San Mateo County Board of Supervisors Meeting

San Mateo County Board of Supervisors Meeting	
Owner/Applicant: PRICE	Attachment: C
File Numbers: PLN2012-00127

FINAL LETTER OF DECISION

SUBJECT: Coastside Design Review

E1.1 ELEVATION NORTHEAST

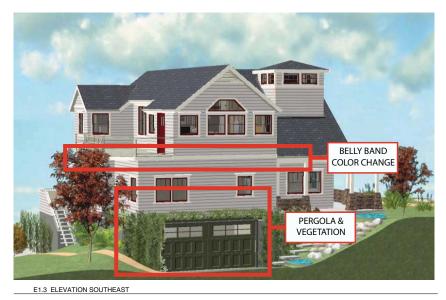
BELLY BAND COLOR CHANGE ADDITIONAL LANDSCAPING **ROOF EXTENSION**
